BCA & Access Assessment Report

Jordan Springs Residential Aged Care Development

> July 2018 Ref.: 180144

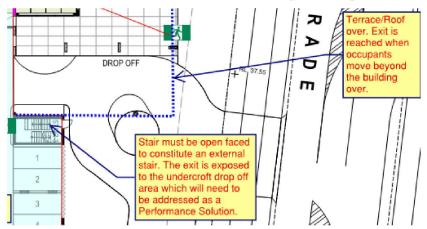
Comments: All required stairs have been designed as external stairs "in lieu of a fire isolated Stair 1 and 2 demonstrate that compliance is readily achievable, i.e. bounded by construction that achieves an FRL of 60/60/60; is not exposed to and/or within any unprotected openings closer than 6m and have no openings within 3m of the stair; nor can it be penetrated at roof level by any structure.

The below stair on Ground Floor is to be further considered to assist in ensuring the stair can be considered as an external stair at all levels.
